Re: Florida Power & Light Company
Proposed Turkey Point Units 6 and 7
Docket Nos. 52-040 and 52-041
Response to NRC Environmental Request for Additional Information Letter
1103094 (RAI 5563) Environmental Standard Review Plan
Section 9.3 – Alternative Sites

NRC RAI Letter No. 1103094 Dated March 9, 2011

NRC RAI Number: EIS 9.3-1 (RAI 5563)

GLADES
CONCEPTUAL SITE LAYOUT

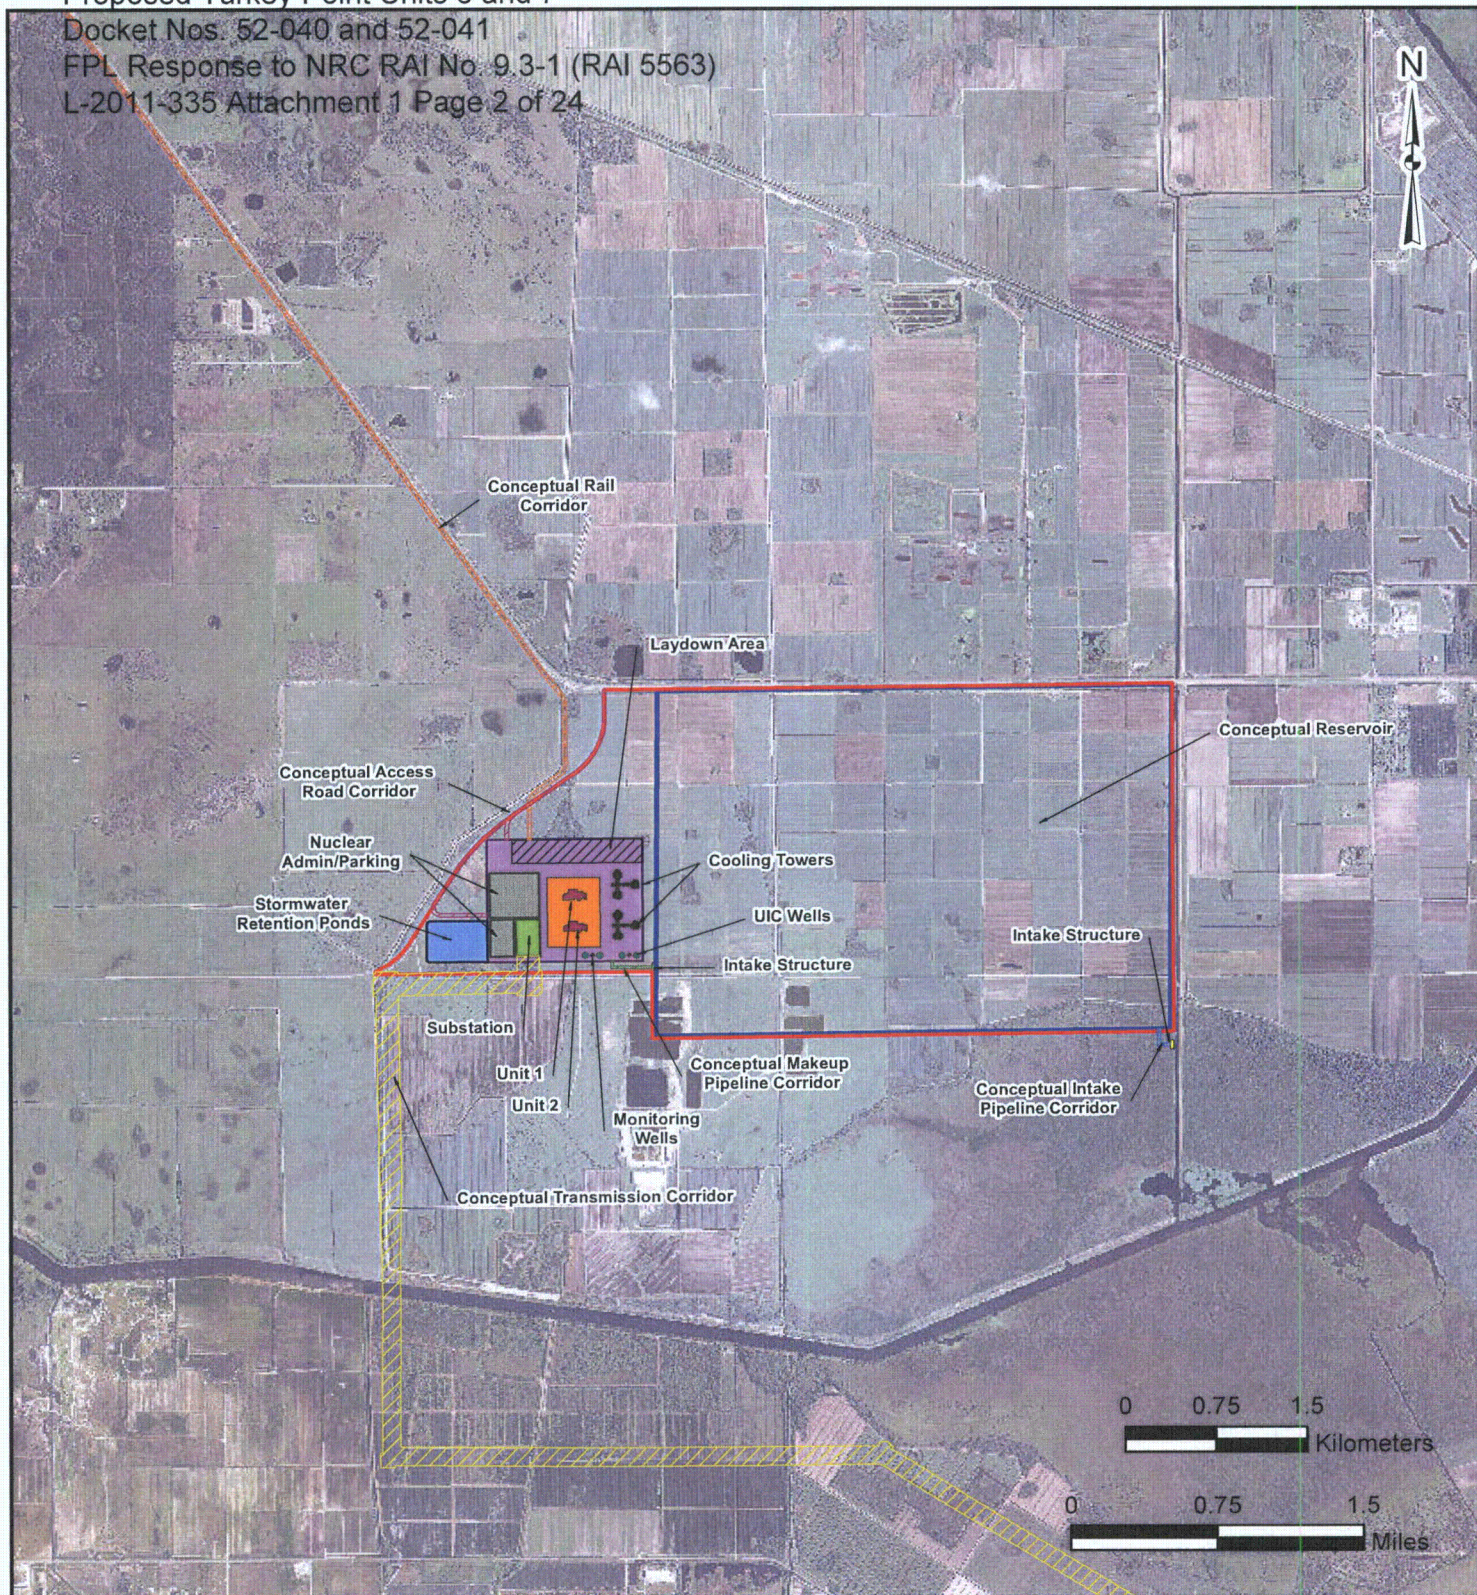
For each alternative site, provide a map showing the site boundaries, assumed facility footprint, and land cover types based (if possible) on 3 digit FLUCCS codes. Provide estimates on area of each land cover type affected for each alternative site. Provide GIS layers so that the review team can independently verify the data. The staff requests this information in order to characterize the baseline ecological conditions at each site, and to provide a common basis for comparing the ecological impacts of each site.

- Figure 1 (4 pages, 1 page per alternative site) – Conceptual site layout depicting assumed site boundaries and the assumed facility footprint, including assumed cooling water storage reservoir where required.
- Figure 2 (4 pages, 1 page per alternative site) – Conceptual site layout depicting the assumed extent of non-transmission linear features, including access road corridors, pipeline corridors, and rail access corridors as appropriate.
- Figure 3 (4 pages, 1 page per alternative site) – Conceptual site layout depicting the assumed extent of conceptual transmission corridor routing.
- Figure 4 (4 pages, 1 page per alternative site) – Conceptual site layout, focused on the assumed site boundary, depicting the FLUCCS Level I land cover types. FLUCCS Level III data is included in the attached GIS files.

GLADES
TRANSMISSION LINE CORRIDORS

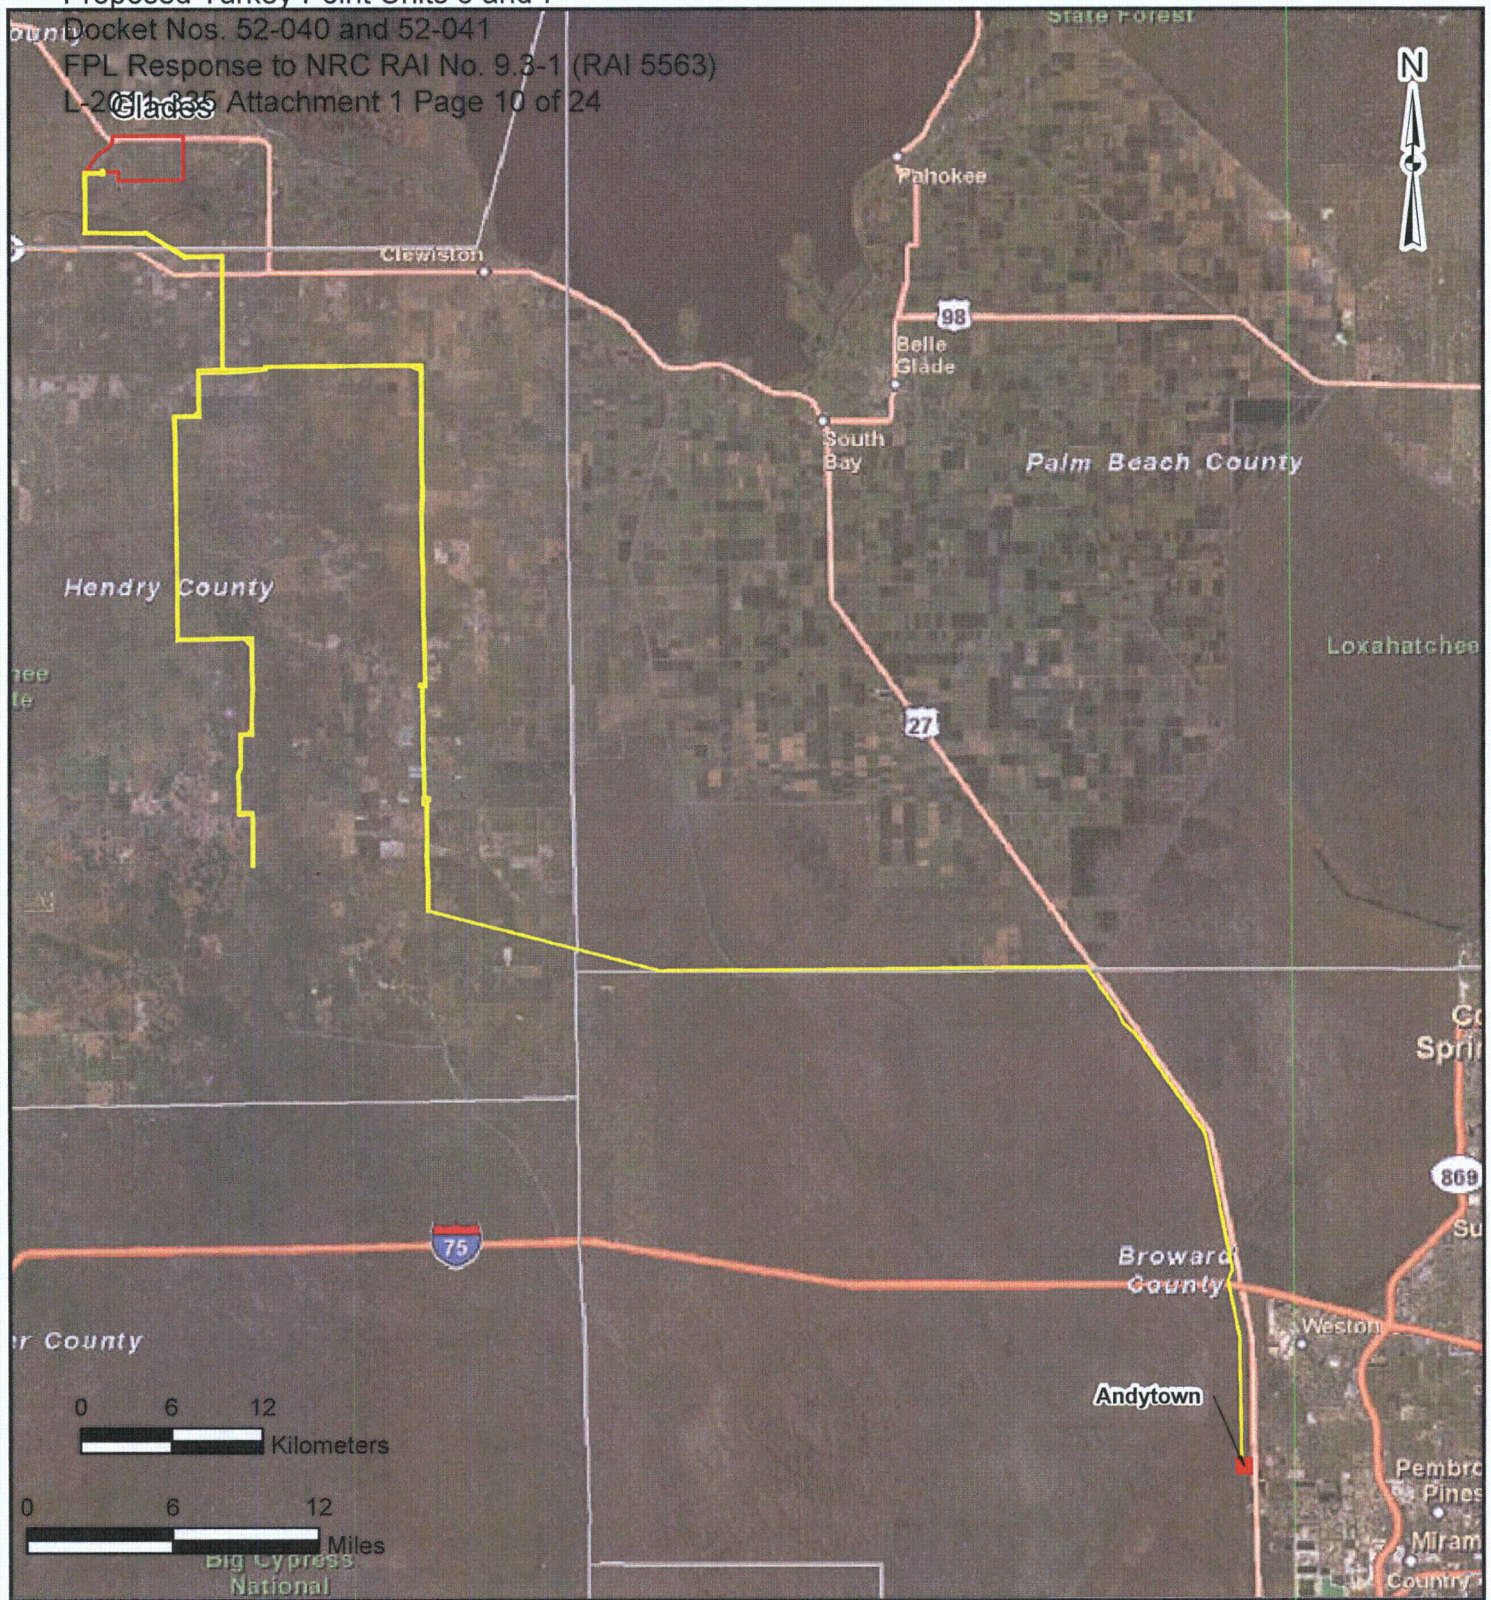
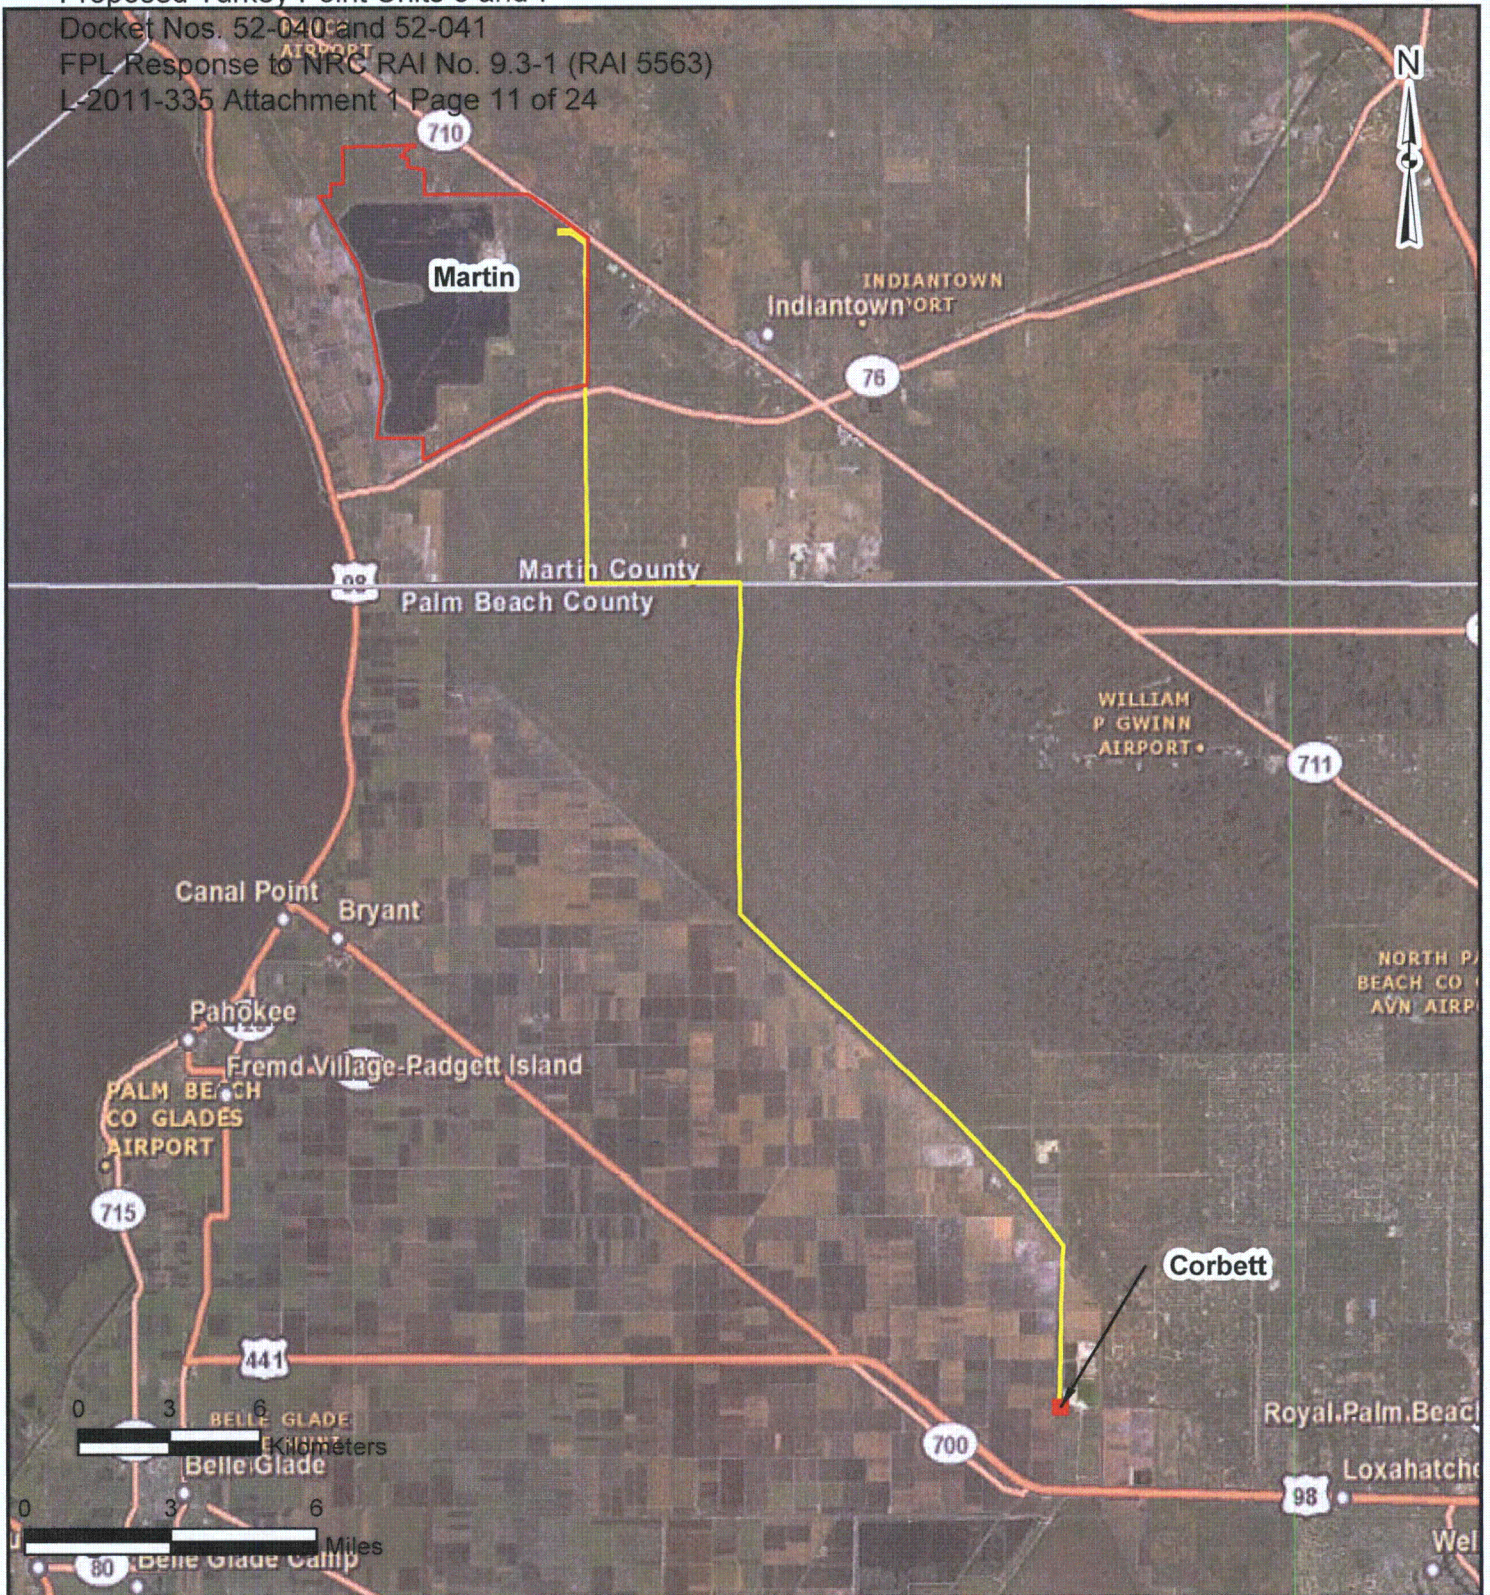
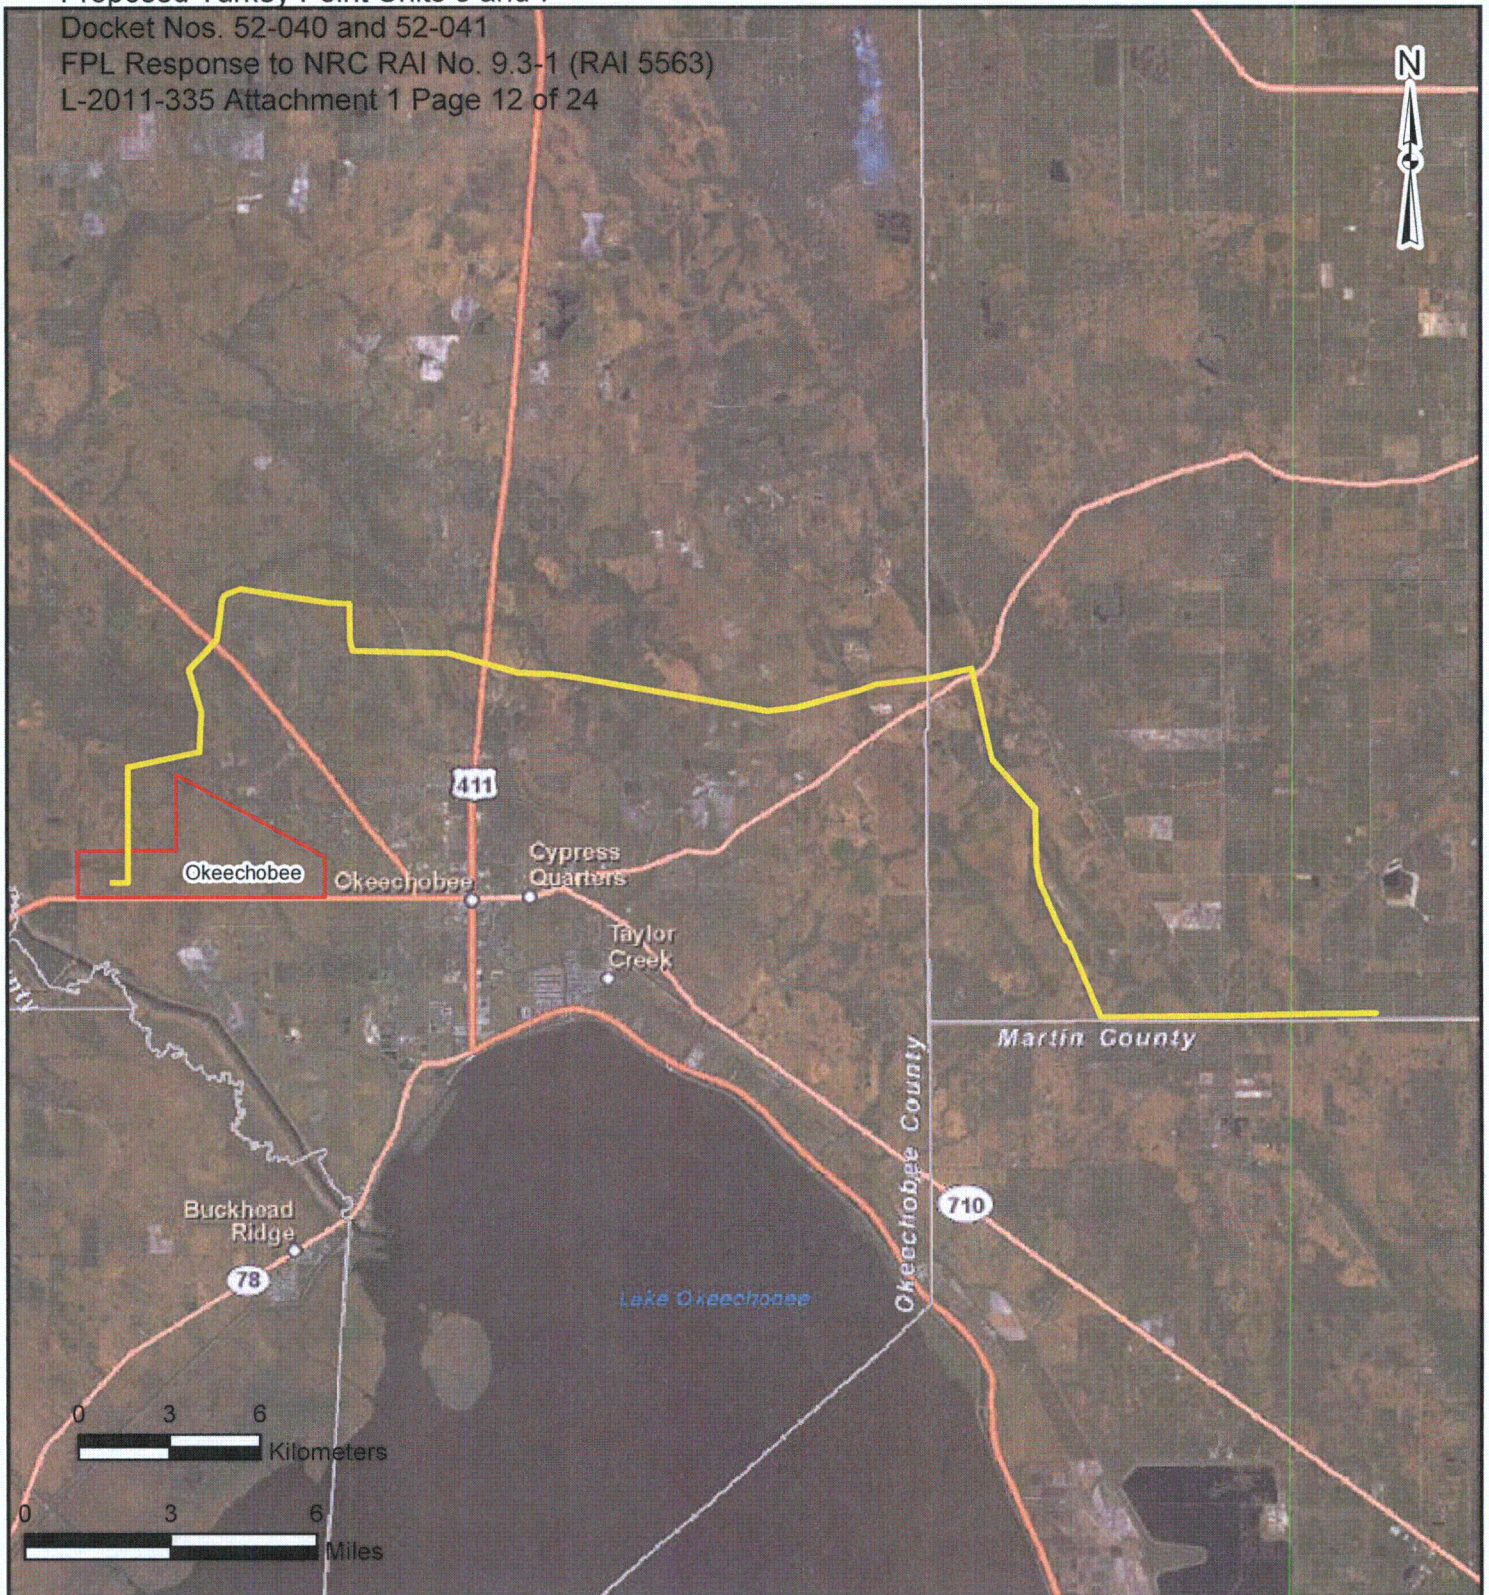
For each alternative site, provide a map showing the site, existing transmission infrastructure, the likely connection point to the regional grid, a generalized route or macro-corridor between the plant site and the connection point, and the land cover types within and near the macro corridor. Provide a summary table, using 3-digit FLUCCS codes if possible, of potentially affected land cover acreage for each alternative site. The staff requests this information in order to compare impacts among the different alternative sites. It is understood that the exact route cannot be determined at this time, but the staff can make qualitative comparisons based on generalized routes, including the proportion of the potential route that would be expected to follow existing transmission corridors or other existing linear features.

The response to RAI 5563 9.3-1 includes a figure for the conceptual site layout at each alternative site depicting the assumed extent of the conceptual transmission corridor routing (Figure 3). For each alternative site, this figure shows the assumed connection point to the regional grid and a conceptual macro-corridor route between the plant site and the connection point. A map showing the existing transmission system in the FPL service territory was included as Figure 9.3-4 in ER Rev. 2. Given the areal extent of the entire conceptual site layout (including conceptual transmission corridor routing), FLUCCS Level III data is included in the GIS files attached with the RAI 5563 9.3-1 response. In the tables below (Tables 1-4), FPL has provided estimates of the potentially affected area(s) of each land cover type (FLUCCS Level III) within the conceptual transmission corridor for each alternative site. The following transmission corridor dimensions were assumed in the conceptual transmission corridor routing:

- Glades site – assumed corridor length = 121 miles, assumed corridor width varies from approximately 200-500 ft.
- Martin site – assumed corridor length = 31 miles, assumed corridor width varies from approximately 200-300 ft.
- Okeechobee site – assumed corridor length = 38 miles, assumed corridor width = 660 ft.
- St. Lucie site – assumed corridor length = 63 miles, assumed corridor width varies from approximately 200-660 ft.
